Public Input No. 207-NFPA 70-2019 [Global Input]

"no less than"
change to
"not less than"

Public Input No. 259-NFPA 70-2020 [Global Input]

FIG # 2

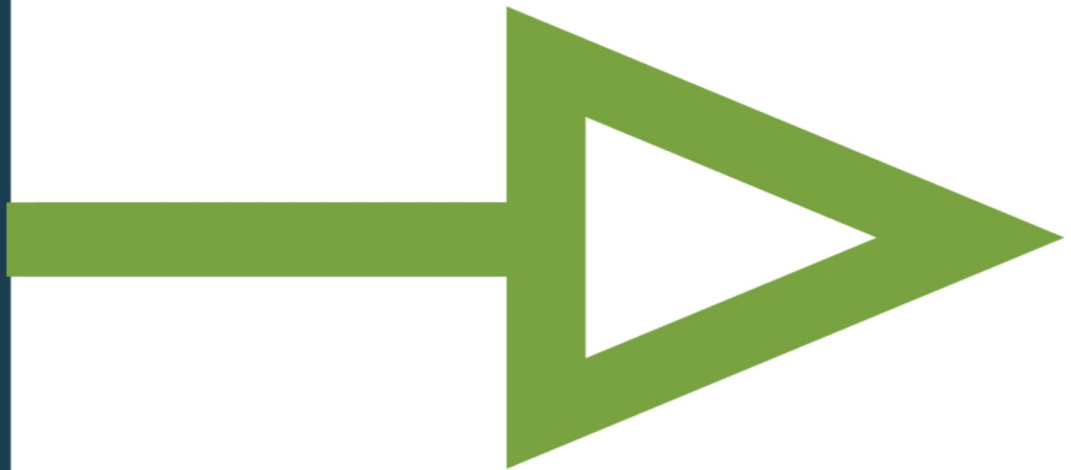
Insert EZ Guard product in each hole that an electrical wire is intended to pass through as shown in fig #2 below.

<u>File Name</u>	<u>Description</u>	<u>Approved</u>
EF55C205-8953-4587-9D37-4D5BCA7027C2.jpeg	Threaded rod in middle of cable tray 1	
8677E567-FC3A-45C0-A456-A3FC30D20331.jpeg	Threaded rod in middle of cable tray 2

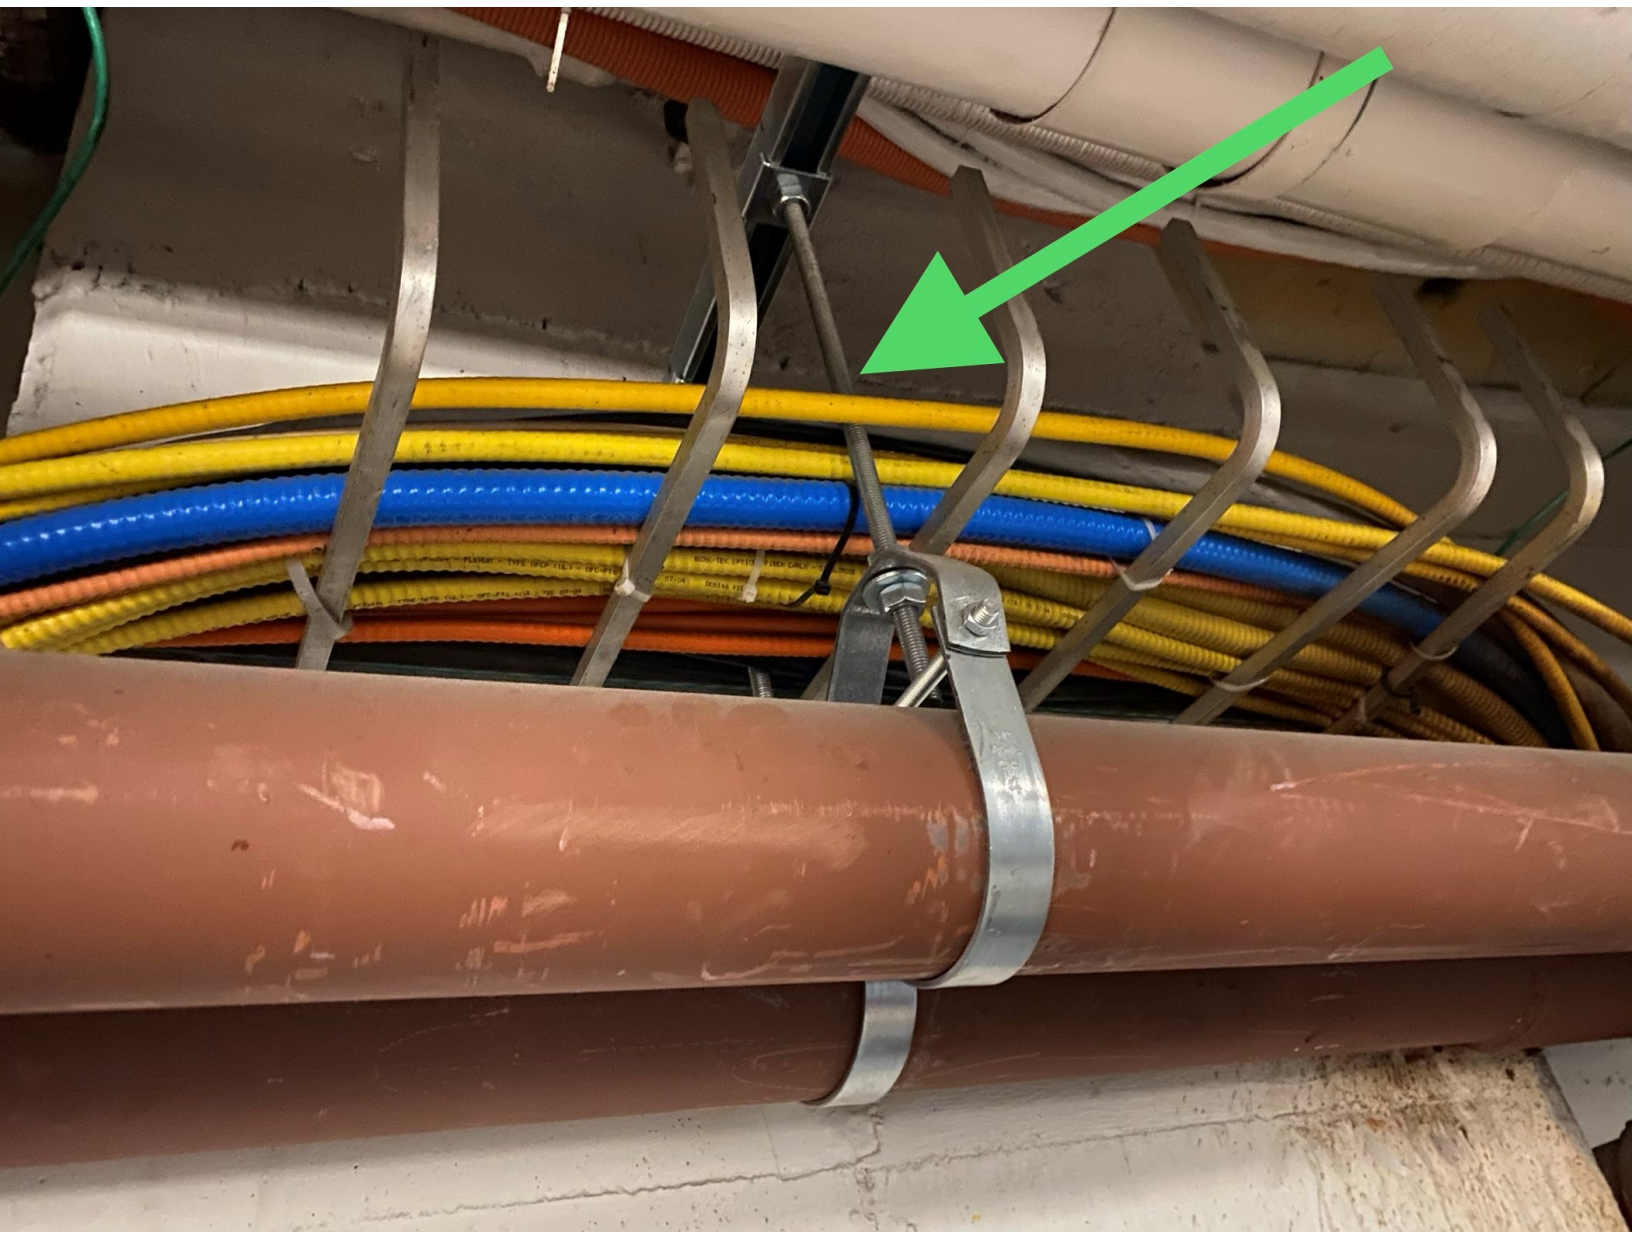
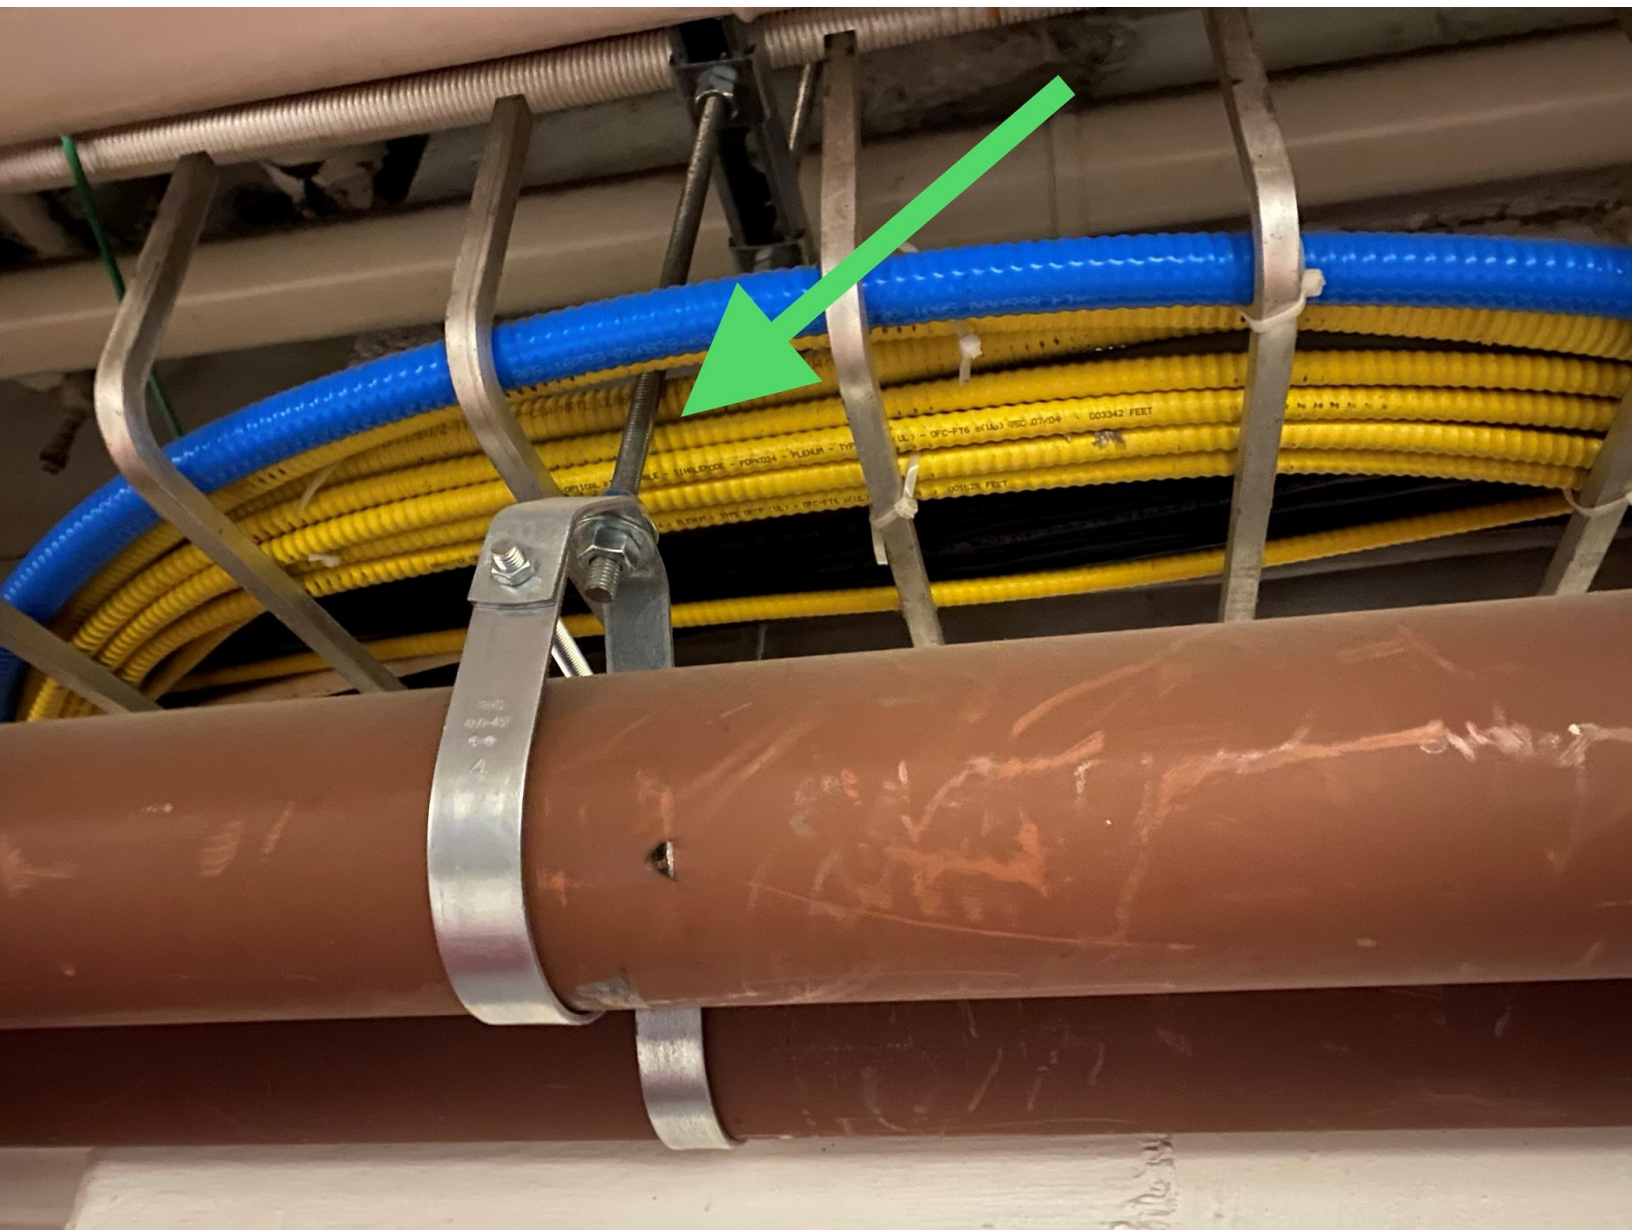
Threaded rods, pipe hangers, brackets and other supporting means for steam pipes, water lines, drain lines, fuel lines and other foreign systems should not be installed in any manner that could interfere with the installation of conductors or cables. These foreign systems could also cause damage to conductors in the cable tray. Threaded rod run right through the middle of a cable tray could easily damage the insulation of conductors, particularly on larger conductors that may be too stiff and rigid to simply roll aside. This revision is needed to include these items in this rule.

Raceways or cable trays containing electrical conductors shall not contain any pipe, tube, or equal, including any supports or support hardware for steam, water, air, gas, drainage, or any service other than electrical.

300.15

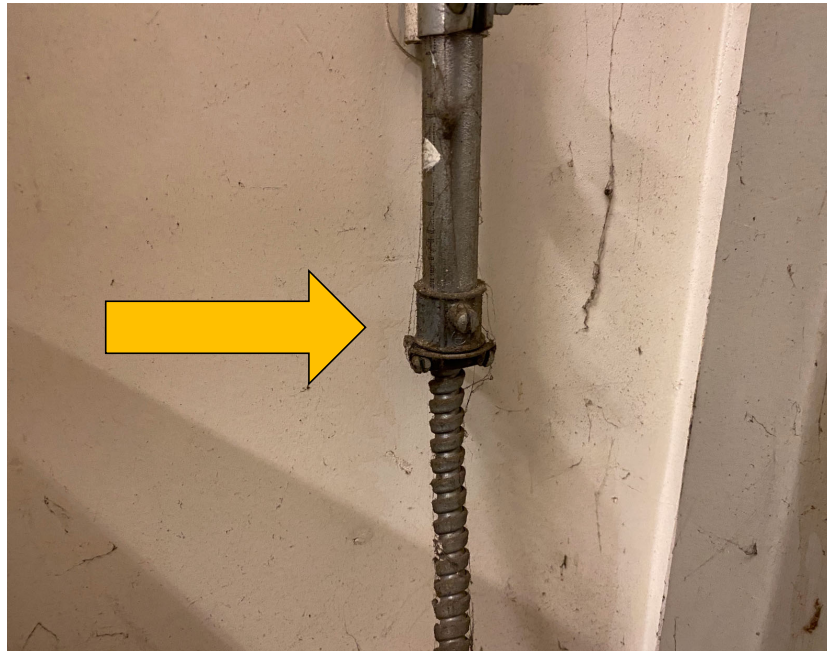
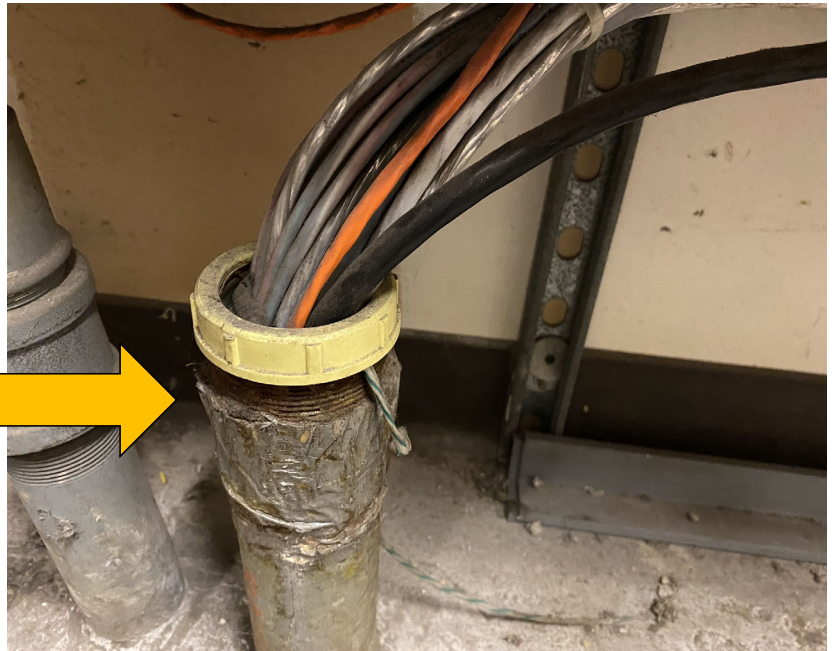
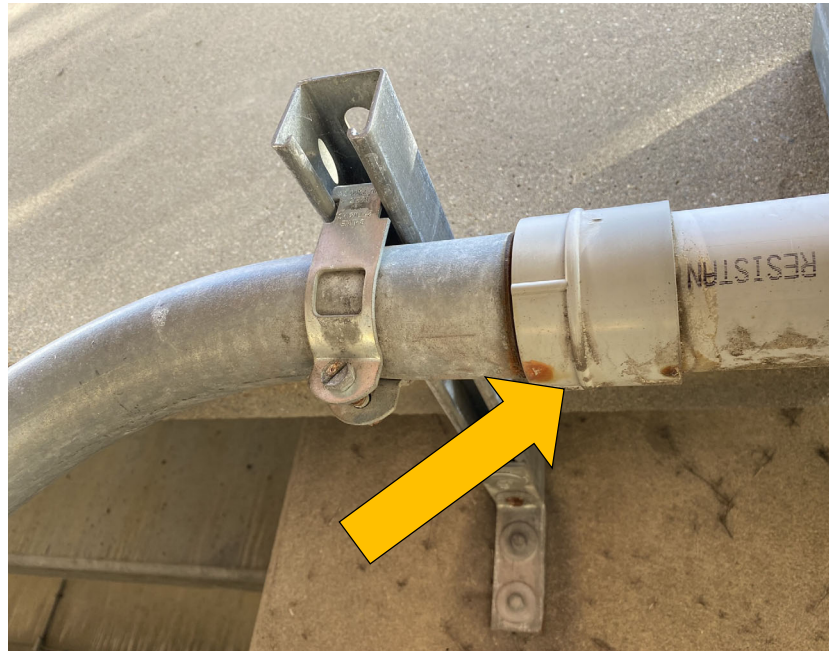
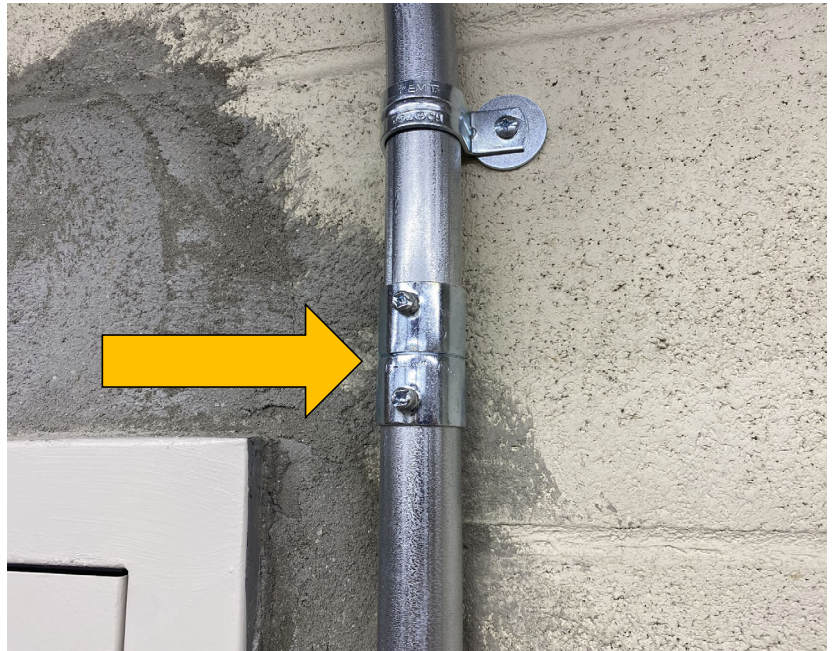
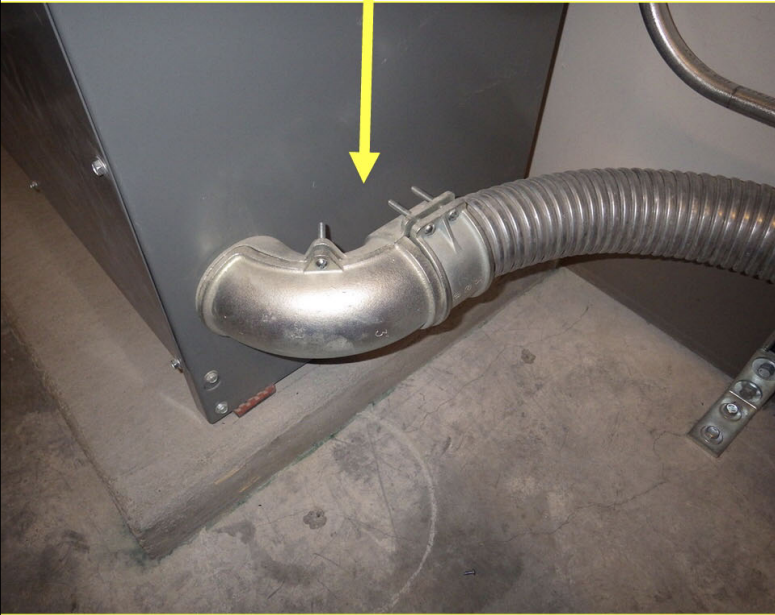
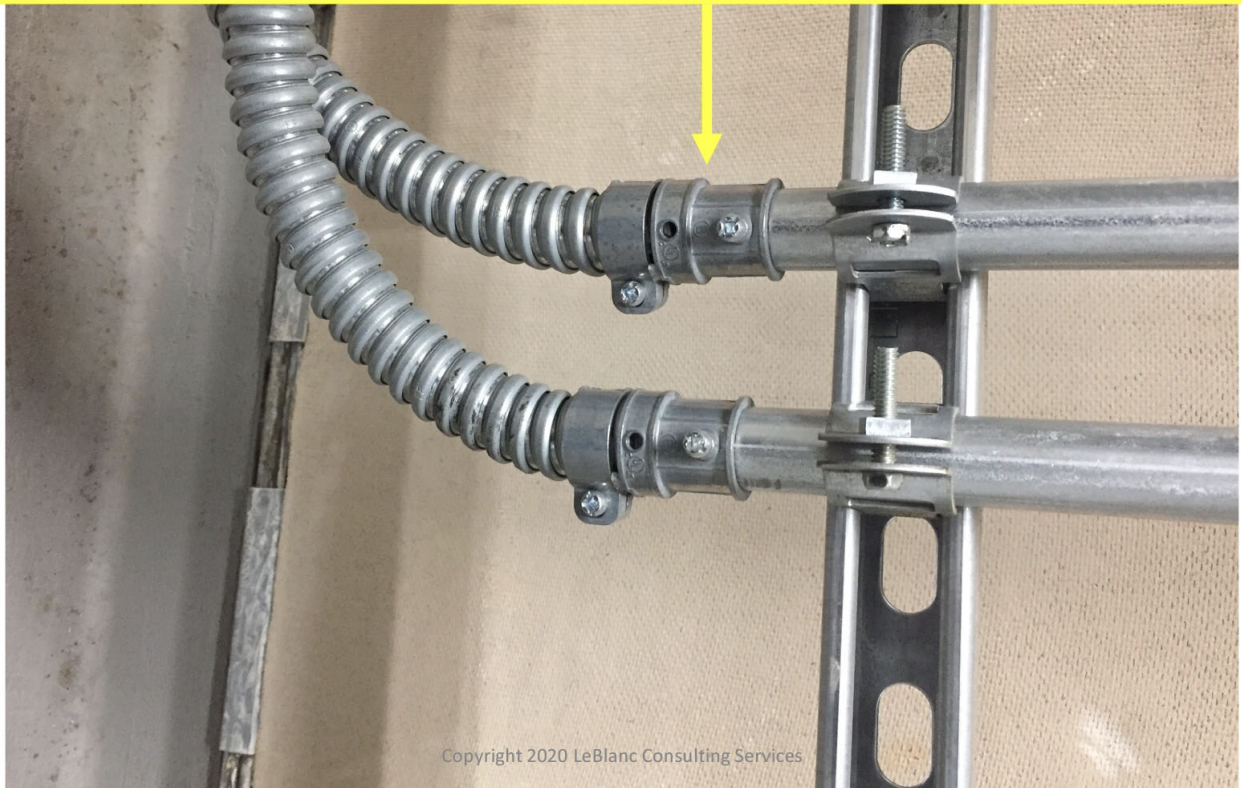
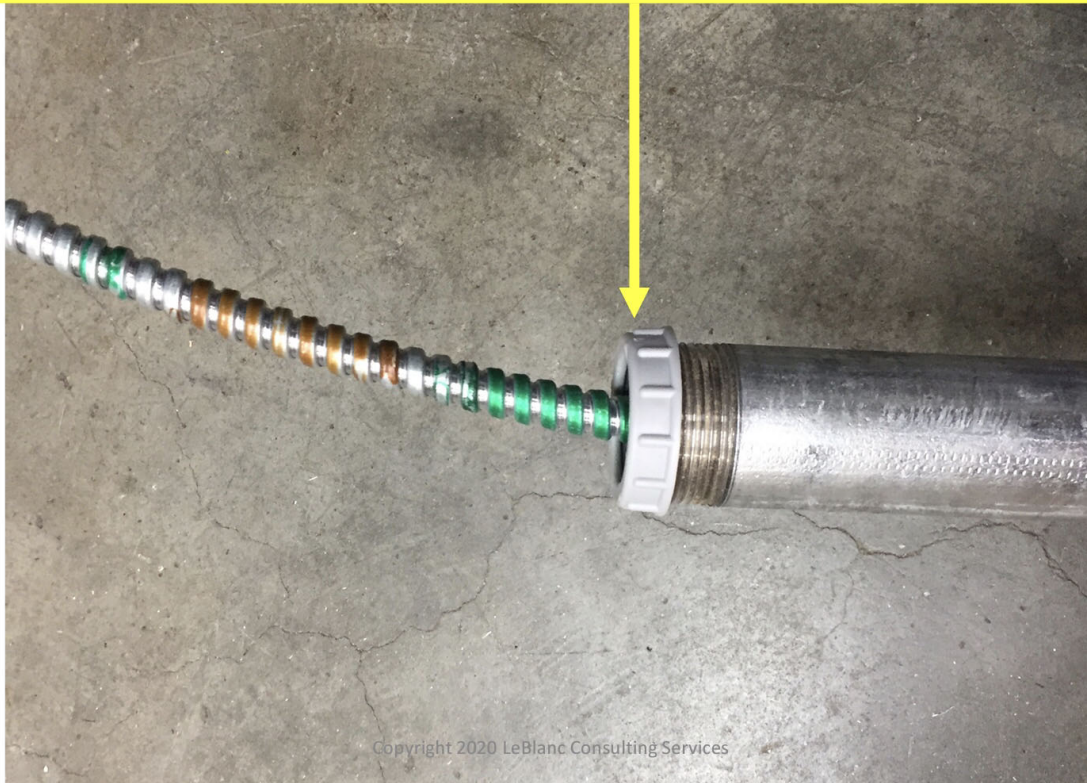
300.15(F)- These types of fittings (in lieu of a boxes) are used as a conductor pull point! These fittings ARE required to remain accessible!

**300.15(F)- A box is NOT required at a conduit transition!
These fittings are NOT required to remain accessible!**

300.15(F)- A box is NOT required on a conduit sleeve!
This fitting is NOT required to remain accessible!

Informational Note No. 2 Figure 726.121(A)(2)

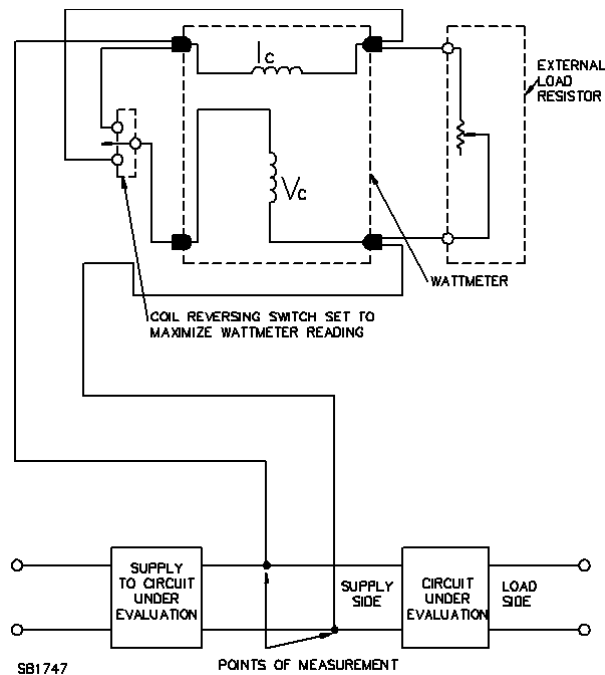
Editor's Note: Should we use 100 watts (PS2 Circuit) or the 15 watts specified for a PS1 circuit in UL 62368-1? "PS1 is a circuit where the power source, (see Figure 36) measured according to 6.2.2, does not exceed 15 W measured after 3 s. No SUPPLEMENTARY SAFEGUARDS are needed for protection against PS1. A PS1 is not considered to contain enough energy to result in materials reaching ignition temperatures."

(2) The maximum power that can be delivered into an external variable resistor/wattmeter circuit connected between conductors or between any conductor and ground shall not exceed 15 VA, measured after 3 seconds.
